City of Boise ADA
Assessment

Appendix A - Watershed Treatment Plant

Report #TO21-B026

ID: 1746 **Facility:** Boise Watershed Treatment Plant

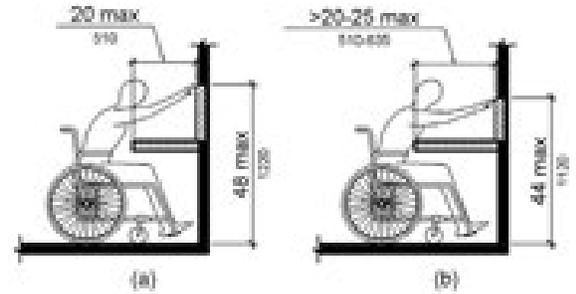
2010 ADA Standards for Accessible Design Codes §308.2.1

The paper towel dispenser is outside of the obstructed forward reach range at 58" above the floor.

Lower the paper towel dispenser by 10" to meet the accessible reach range of 48" maximum above the floor.

ID: 1744 **Facility:** Boise Watershed Treatment Plant

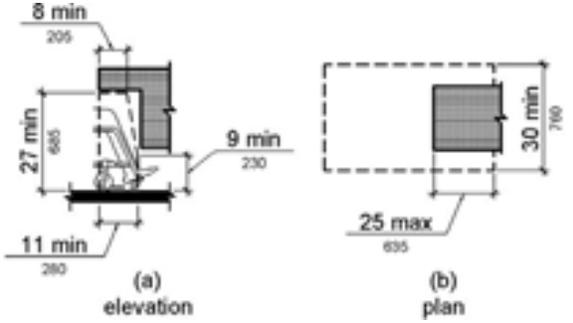
2010 ADA Standards for Accessible Design Codes §902.3, §306.3.3
There is no knee clearance underneath the sink.
The dining and work surface counter is 34.75" above the floor.

Provide knee clearance underneath the counter at the sink that is a minimum of 11" deep at 9" above the floor and 8" deep at 27" above the floor.
A portion of the dining and work surface must be no higher than 34" above the floor.

ID: 1747 **Facility:** Boise Watershed Treatment Plant

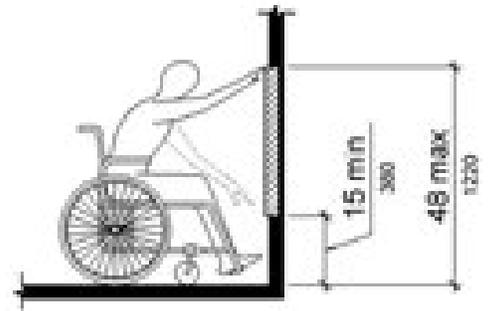
2010 ADA Standards for Accessible Design Codes §308.2.1

The vending machine controls are outside of the unobstructed forward reach at 60.5" above the floor.

Lower the vending machine controls by 12.5" to meet the accessible reach range of 15" minimum and 48" maximum above the floor.

This may require replacing the vending machine

ID: 1748 **Facility:** Boise Watershed Treatment Plant

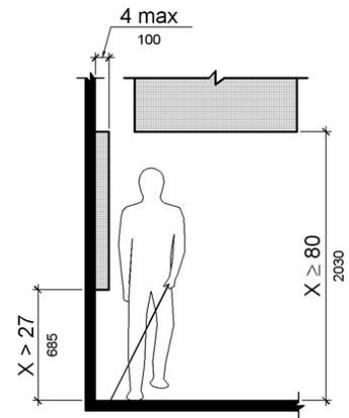
2010 ADA Standards for Accessible Design Codes §307.2

The TV protrudes 5.5" into the circulation space at 74" above the floor.

Recess the TV so it protrudes a maximum of 4", raise it so the bottom edge is 80" maximum above the floor, or place a cane detectable object beneath it.

ID: 1739 **Facility:** Boise Watershed Treatment Plant

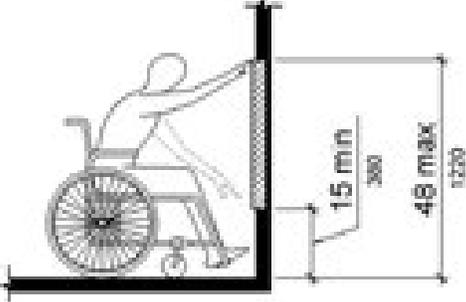
2010 ADA Standards for Accessible Design Codes §308.2.1
The toilet seat covers are outside of the obstructed forward reach range at 59" above the floor.

Lower the toilet seat covers container by 11" to meet the accessible reach range of 48" maximum above the floor and ensure it is at least 12" above the rear grab bar.

ID: 1742 **Facility:** Boise Watershed Treatment Plant

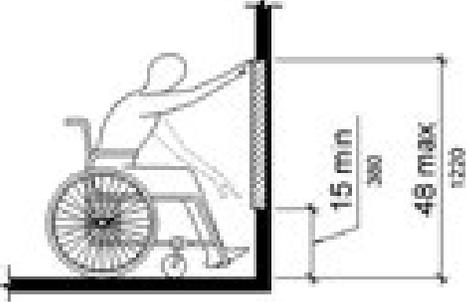
2010 ADA Standards for Accessible Design Codes §308.2.1
The paper towel dispenser is outside of the unobstructed forward reach range at 54" above the floor.

Lower the paper towel dispenser by 6" to meet the accessible reach range of 48" maximum above the floor.
This will require moving the changing table or the paper towel dispenser to another location.

ID: 1749 **Facility:** Boise Watershed Treatment Plant

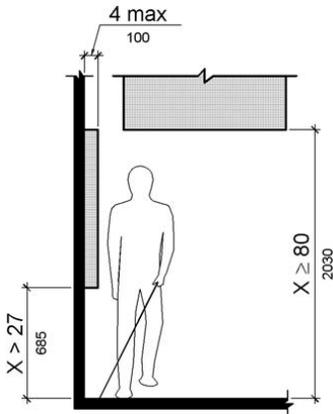
2010 ADA Standards for Accessible Design Codes §307.2
The first aid box protrudes 6.75" into the circulation space at 40.5" above the floor.

Recess the first aid box so it protrudes a maximum of 4" or place a cane detectable object beneath it.

ID: 1738 **Facility:** Boise Watershed Treatment Plant

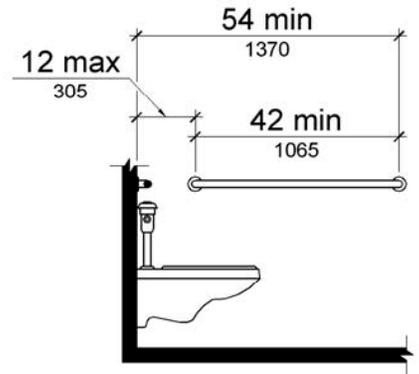
2010 ADA Standards for Accessible Design Codes §604.5.1

The side grab bar is located 11.5" from the rear wall.

Remount the side grab bar 12" maximum from the rear wall and extending 54" minimum from the rear wall.

ID: 1751 **Facility:** Boise Watershed Treatment Plant

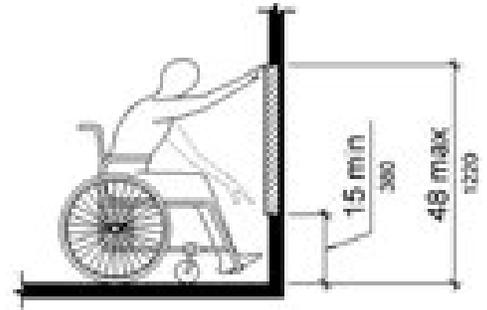
2010 ADA Standards for Accessible Design Codes §308.2.1

The paper towel dispenser is outside of the unobstructed forward reach range at 54" above the floor.

Lower the paper towel dispenser by 6" to meet the accessible reach range of 48" maximum above the floor.

This will require moving the changing table or the paper towel dispenser to another location.

ID: 1753 **Facility:** Boise Watershed Treatment Plant

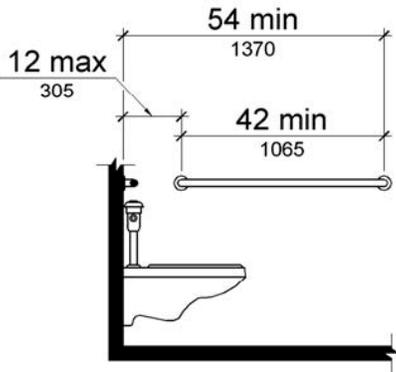
2010 ADA Standards for Accessible Design Codes §604.5.1
The side grab bar is located 11.5" from the rear wall.

Remount the side grab bar 12" maximum from the rear wall and extending 54" minimum from the rear wall.

ID: 1752 **Facility:** Boise Watershed Treatment Plant

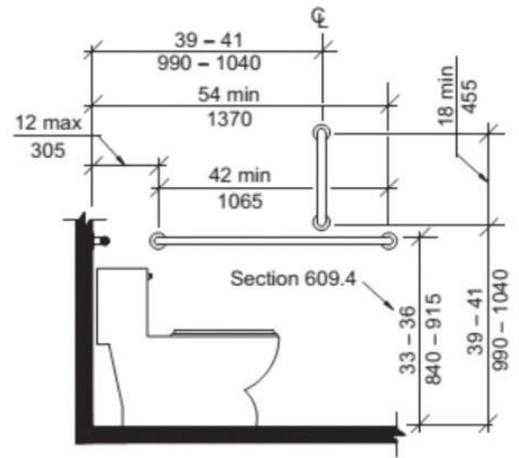
2010 ADA Standards for Accessible Design Codes ICC A117 §604.5.1

The accessible water closet does not have a vertical grab bar.

Install an 18" long (minimum) vertical grab bar on the side wall. The grab bar shall be mounted with the bottom located at 39" minimum and 41" maximum above the floor.

The centerline of the vertical grab bar shall be located 39" minimum and 41" maximum from the rear wall.

ID: 1754 **Facility:** Boise Watershed Treatment Plant

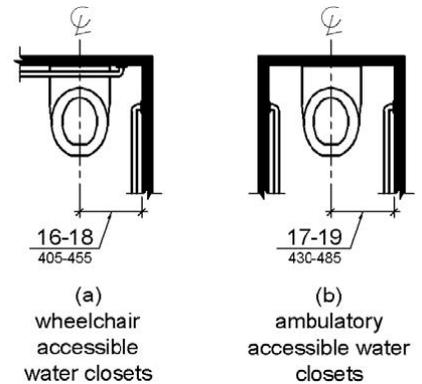
2010 ADA Standards for Accessible Design Codes §604.2

The centerline of the toilet is located 19" from the sidewall.

Reposition the centerline of the toilet to be within 16" minimum and 18" maximum from the sidewall.

ID: 1837 **Facility:** Boise Watershed Treatment Plant

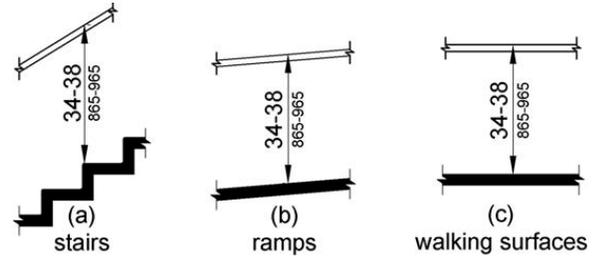
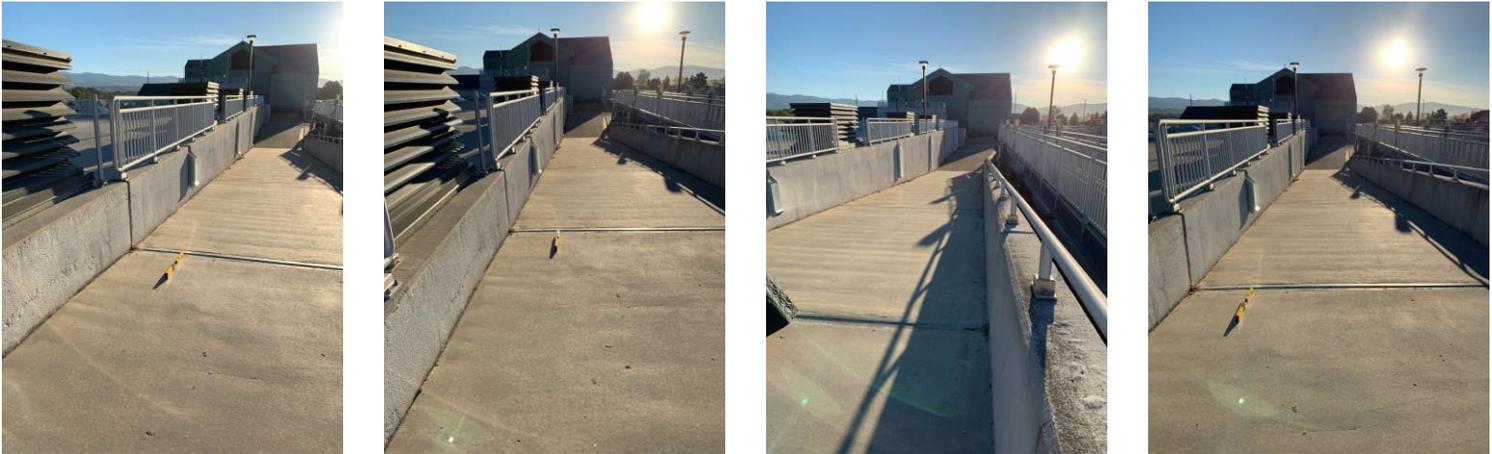
2010 ADA Standards for Accessible Design Codes §505.2, §405.2

Although this ramp is designed for vehicles, tours are led here to go to the Aeration Basins. The running slope of the ramp is 9.2%. There are no handrails.

Reconstruct the ramp to reduce the running slope to a maximum of 8.3% or consider allowing the patron's vehicle or an accessible golf cart traverse the ramp when needed.

Install handrails at a minimum height of 34" and maximum of 38" above the ground. Make sure there are adequate handrail extensions both at the top and bottom of the handrail.

ID: 1731 **Facility:** Boise Watershed Treatment Plant

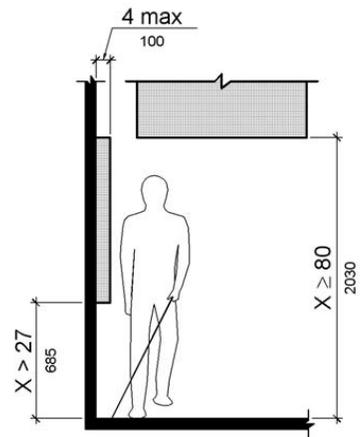
2010 ADA Standards for Accessible Design Codes §307.2
The card scanner protrudes 8.5" into the circulation space at 38" above the floor.

Recess the card scanner so it protrudes a maximum of 4" or place a cane detectable object beneath it.

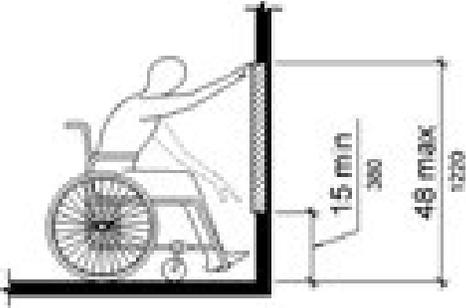
2010 ADA Standards for Accessible Design Codes §308.2.1
 The hooks are outside of the unobstructed forward reach range at 54" above the floor.

Lower at least one of the hooks by 6" to meet the accessible reach range of 48" maximum above the floor.

ID: 1783 **Facility:** Boise Watershed Treatment Plant

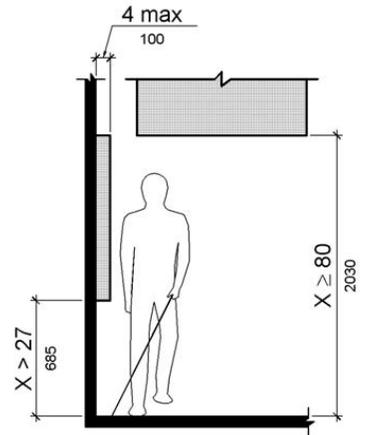
2010 ADA Standards for Accessible Design Codes §307.2, §308.2.1
The AED is outside of the unobstructed forward reach range at 49" above the floor.
The AED protrudes 6" into the circulation space at 49" above the floor.

Lower the AED by 1" to meet the accessible reach range of 48" maximum above the floor.
Recess the AED so it protrudes a maximum of 4" or place a cane detectable object beneath it.

ID: 1764 **Facility:** Boise Watershed Treatment Plant

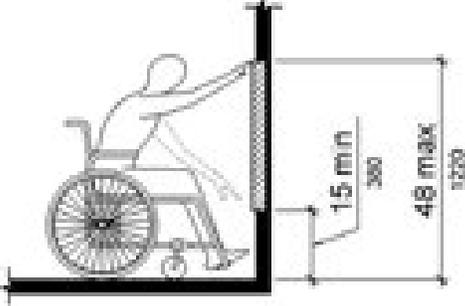
2010 ADA Standards for Accessible Design Codes §308.2.1

The hand sanitizer dispenser is outside of the unobstructed forward reach range at 54" above the floor.

Lower the hand sanitizer dispenser by 6" to meet the accessible reach range of 48" maximum above the floor.

ID: 1766 **Facility:** Boise Watershed Treatment Plant

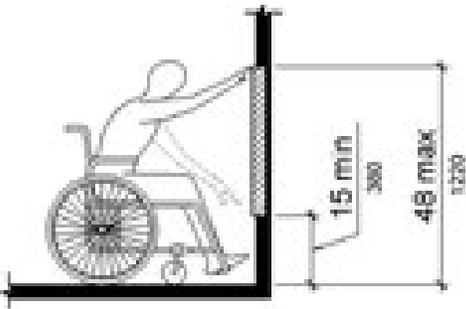
2010 ADA Standards for Accessible Design Codes §308.2.1

The paper towel dispenser is outside of the unobstructed forward reach range at 56" above the floor.

Lower the paper towel dispenser by 8" to meet the accessible reach range of 48" maximum above the floor.

ID: 1763 **Facility:** Boise Watershed Treatment Plant

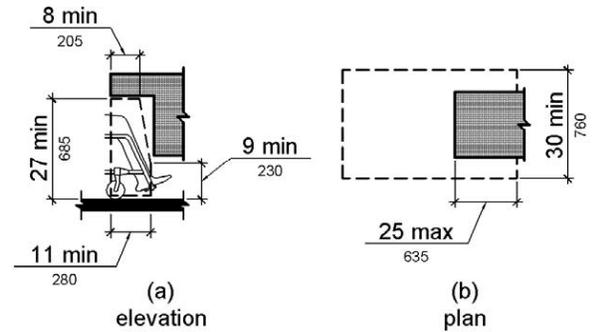
2010 ADA Standards for Accessible Design Codes §606.3, §306.3.3

The sink is 36" above the floor.

There is no knee clearance underneath the sink.

Lower the sink to the maximum height of 34" above the floor.

Provide knee clearance underneath the counter at the sink that is a minimum of 11" deep at 9" above the floor and 8" deep at 27" above the floor.

ID: 1786 **Facility:** Boise Watershed Treatment Plant

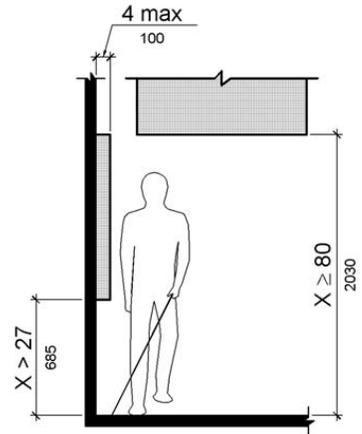
2010 ADA Standards for Accessible Design Codes §307.2

The card swipe protrudes 8.5" into the circulation space at 38" above the floor.

Recess the card swipe so it protrudes a maximum of 4" or place a cane detectable object beneath it.

ID: 1779 **Facility:** Boise Watershed Treatment Plant

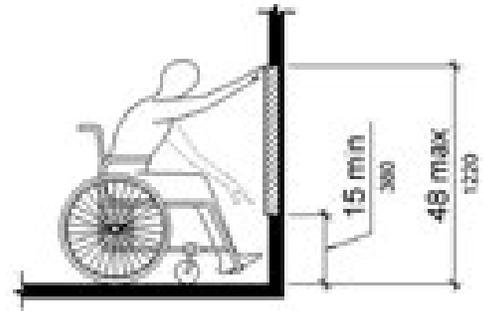
2010 ADA Standards for Accessible Design Codes §308.2.1

The toilet seat covers are outside of the unobstructed forward reach range at 52" above the floor.

Lower the toilet seat covers by 4" to meet the accessible reach range of 48" maximum above the floor.
